PLANNING COMMISSION REGULAR MEETING

4. SUP 2023-04 Taylor Middle School - The Applicant is requesting a Special Use Permit for an expansion to an existing middle school. The property is zoned Public-Semi Public (PSP) on approximately 39.18 acres. The site includes Brumfield Elementary. Article 3-4.9.3 of the Town of Warrenton's Zoning Ordinance allows school expansion to existing facilities equal to or over 10,000 square feet with the approval a SUP by Town Council.

PROJECT: TAYLOR MIDDLE SCHOOL ADDITION & RENOVATION
FAUQUIER COUNTY PUBLIC SCHOOLS
 350 EAST SHIRLEY AVENUE
 WARRENTON, VA 20186
 VIRGINIA DEPARTMENT OF EDUCATION: 03B-67-06-01
 DRAWING: OVERALL SPECIAL USE PERMIT PLAN
 FEB TED

Future Geometry and Stop Control Taylor Middle School – Addition Town of Warrenton, Virginia

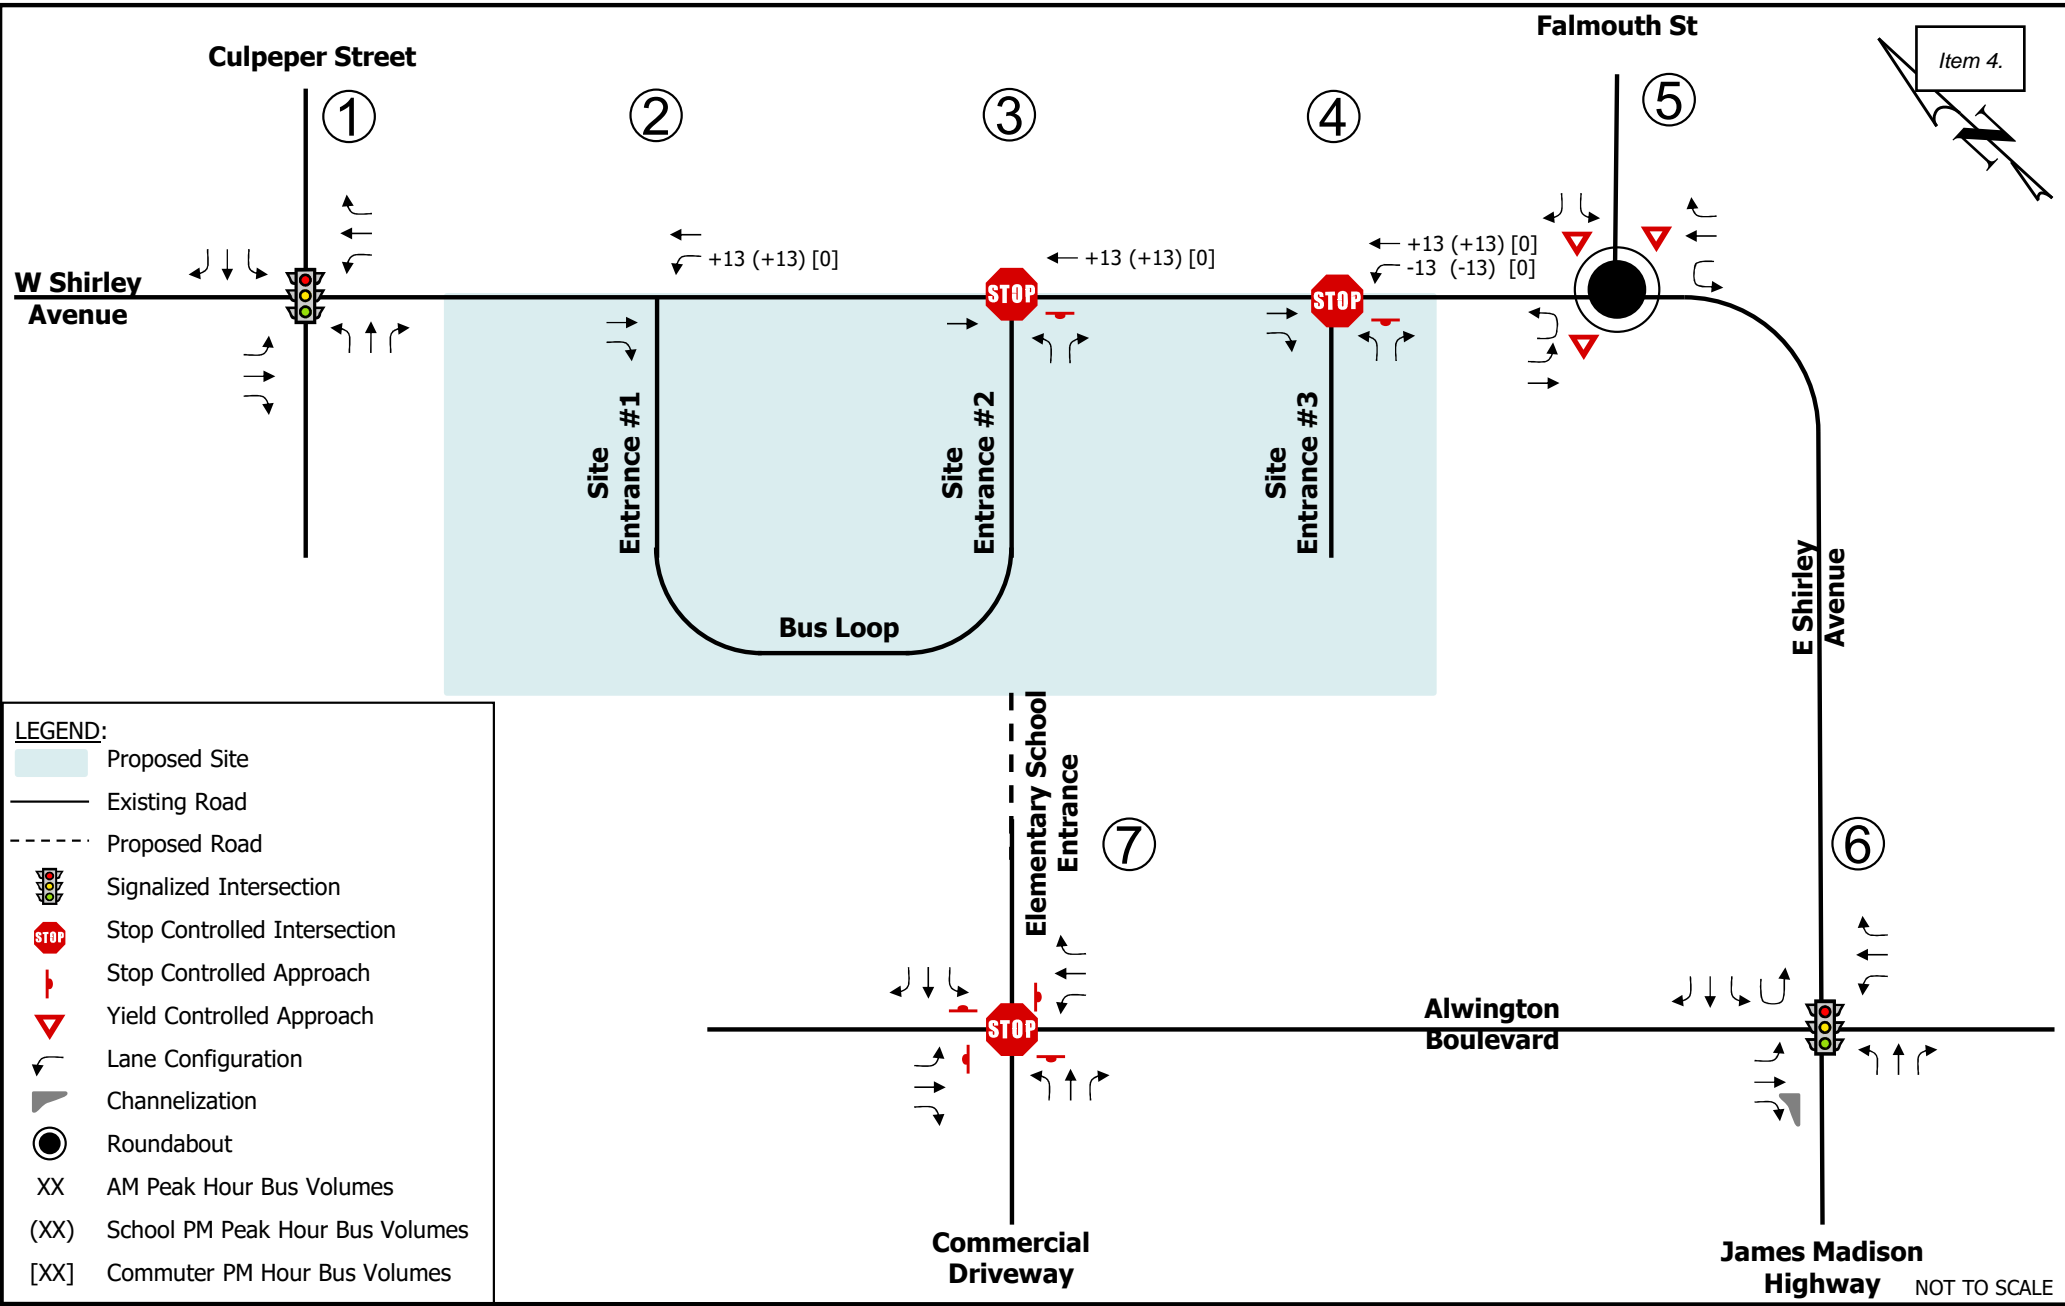
14. Figure 5-4: Recommend capitalizing Hour for AM Peak Hour Bus Trips. It is unclear why there is "School PM" but not "School AM" - just "AM"

SHEET
C3.00

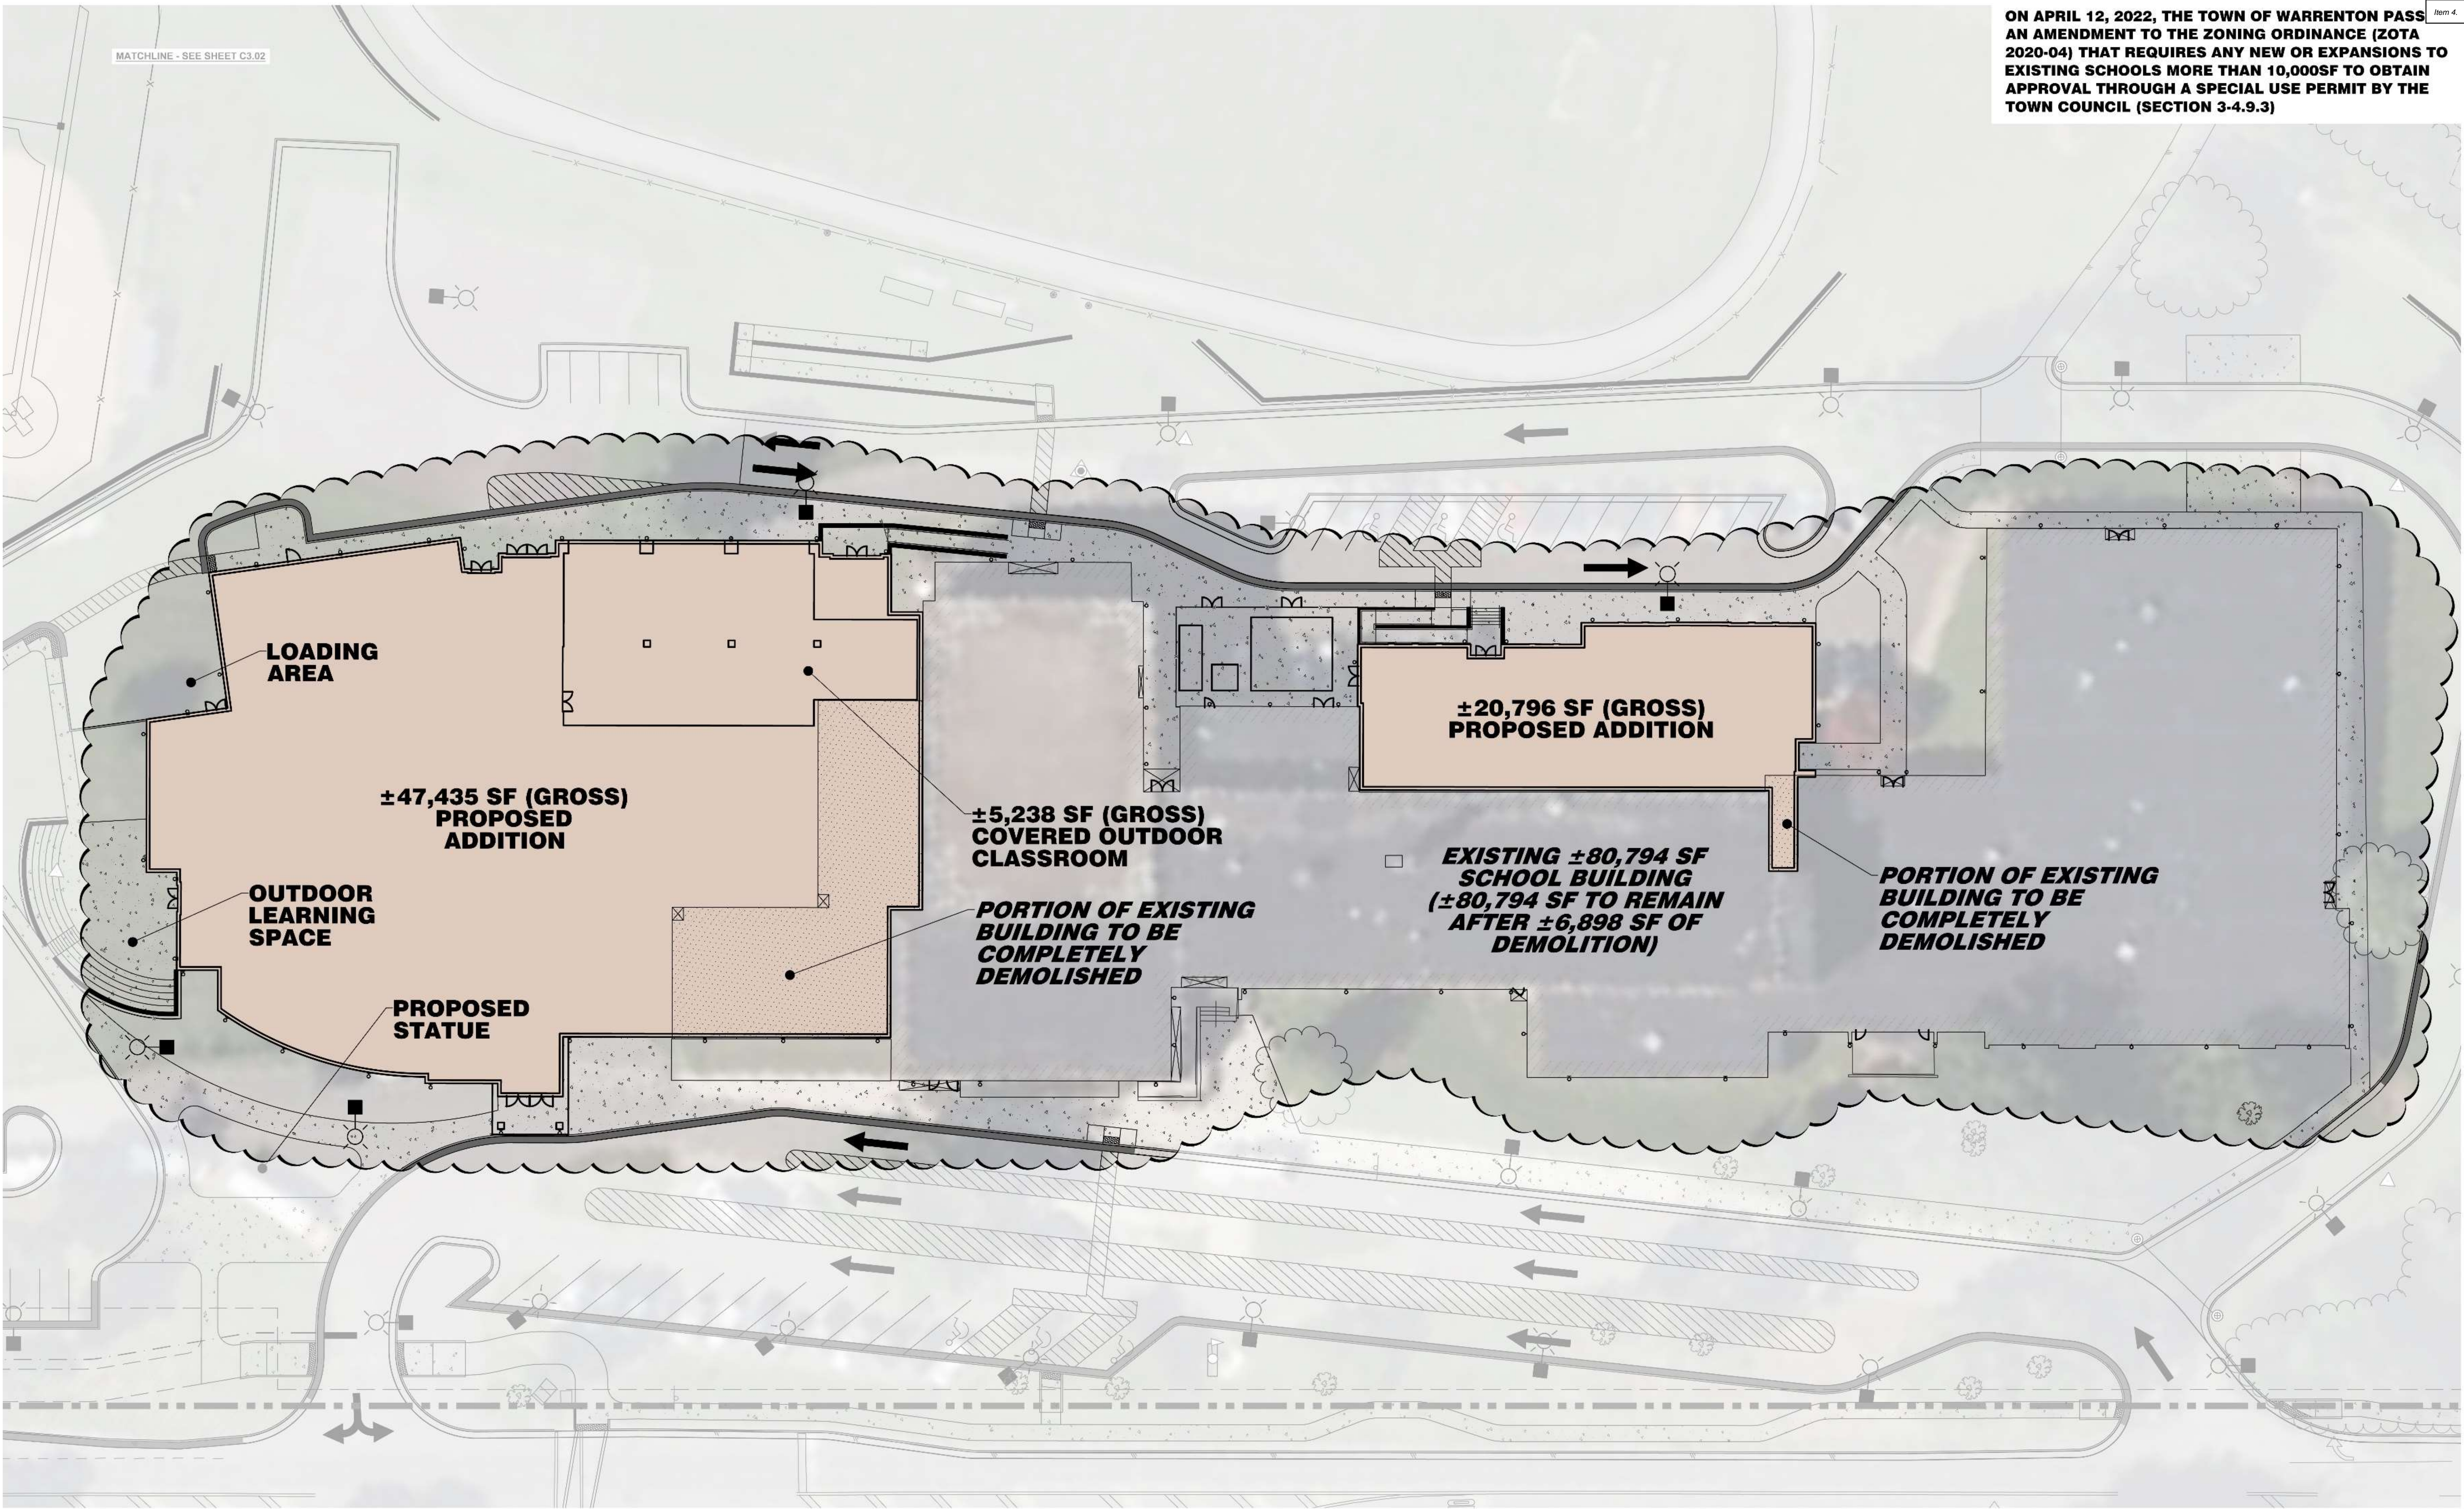
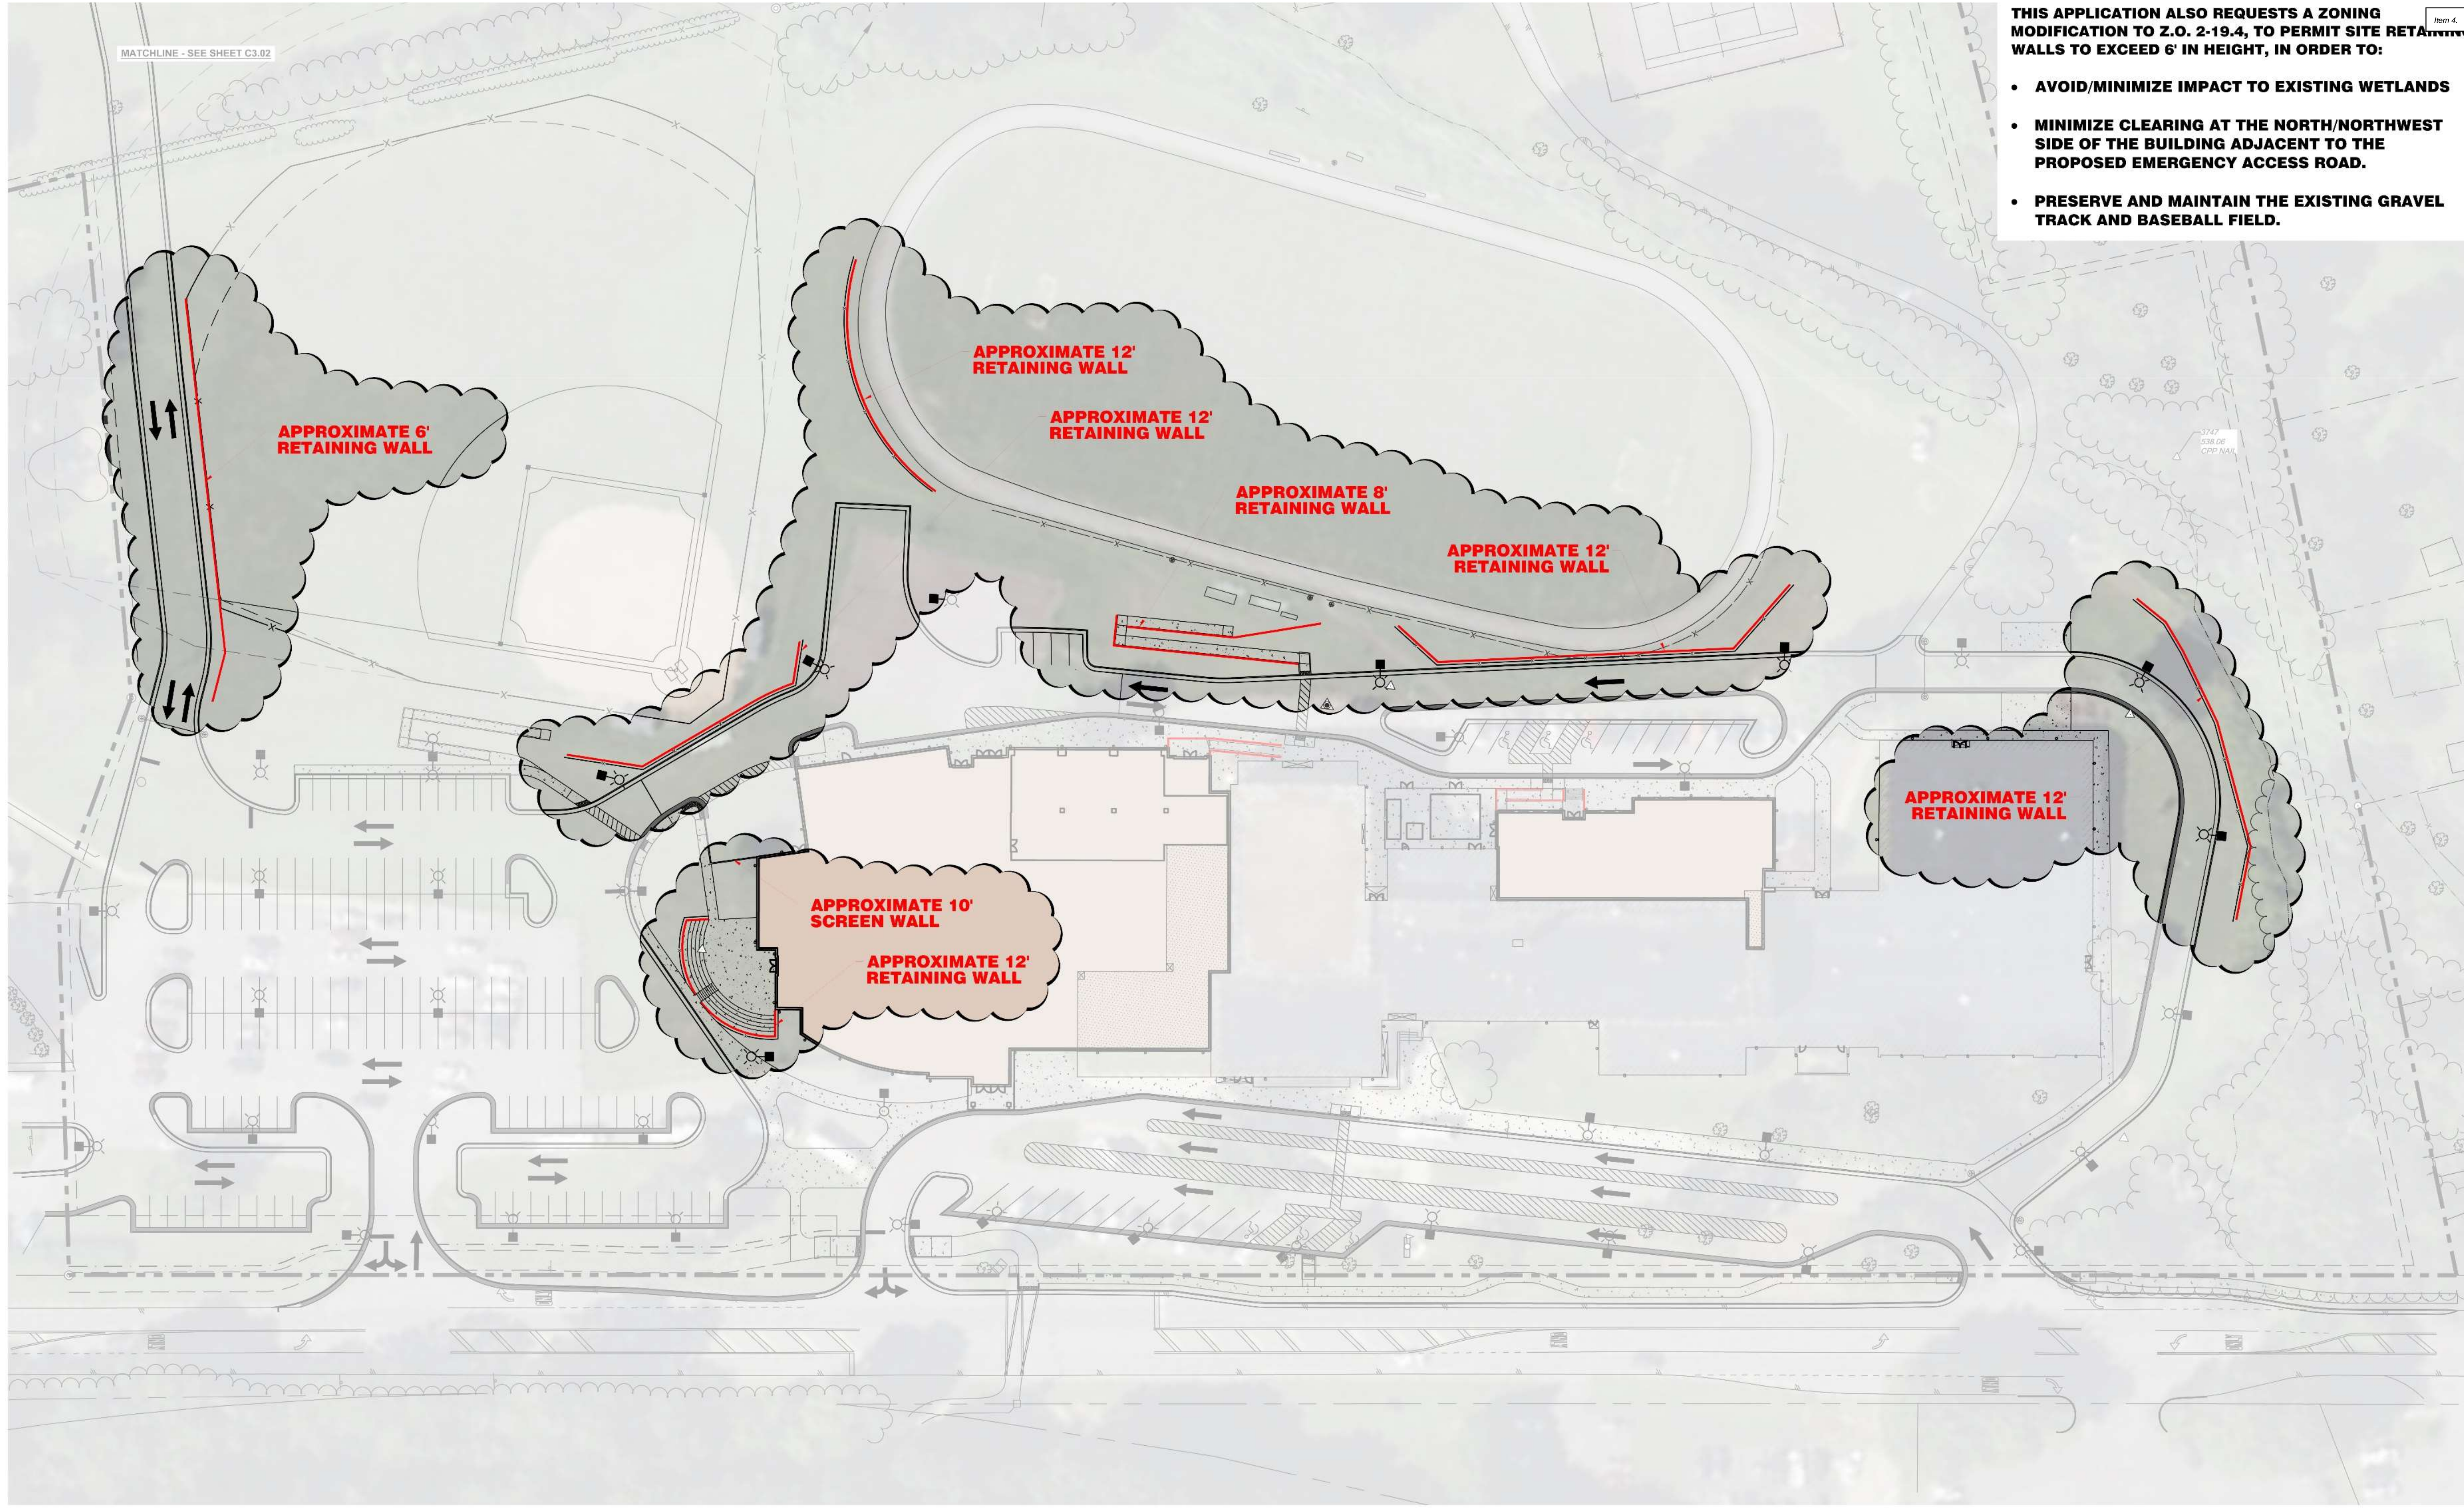
2. Please update the SUP plans to add a combined sheets C3.01 and C3.02 with all existing and proposed conditions that include Brumfield Elementary and the land adjacent to Walmart.

2. There is a screen wall labeled on sheet C3.01, but there are no height details. Fencing and walls in excess of 6' in height may be approved in conjunction with a special use permit for permissible uses listed within Article 3.

5. Replacement of an existing monument sign is mentioned on sheet C3.01 of the plan and in the statement of justification. No details are provided on the signage, and staff is unable to verify signage will meet all requirements of Article 6. Include a prominent note on the plan and revise the statement of justification to note signage will be addressed at the time of site development plan.

The proposed 12' retaining wall shown on the plan page C3.01 is an ongoing safety issue for a middle school campus. The presence of a 42" fence at the top, as addressed in the Timmons Group Jan. 12 letter, does not necessarily mitigate the impact of this safety issue under the circumstances presented. The justification advanced for the retaining wall in excess of 6' consists solely of (1) minimizing impact to wetlands, (2) minimize clearing on that side of the building adjacent to the proposed emergency access road, and (3) maintaining the existing gravel track and

- The special use permit plan (C3.01) shows storage lengths that are not consistent with the storage listed on page 6-4. The western entrance (Site Entrance #1) right turn has storage of 85 feet and taper of 50 feet. The northbound left turn for this entrance has 50 feet of taper length that is not

Response: The above sheet has been added. See sheet C3.00.

Response: Screen wall at dumpster enclosure is proposed to be 10' max above grade. Screen wall (fence) around mechanical yard is proposed to be 10' max above grade. Details will be provided at time of stie plan. Please see Sheet C3.01 for updated callouts. However, construction type and materials will be compatible with the existing and proposed buildings.

Response: Note #3 has been added, stating that the proposed signage will be provided in accordance with requirements set forth by the Town of Warrenton Zoning Ordinance. Specific details will be provided at the time of site plan. Please see Sheet C3.01.

Response: A hydrant has been added on the same side of the building as the FDC. See sheet C3.01.

Response: The locations for all fire hydrants have been added to the plan. See sheet C3.01.
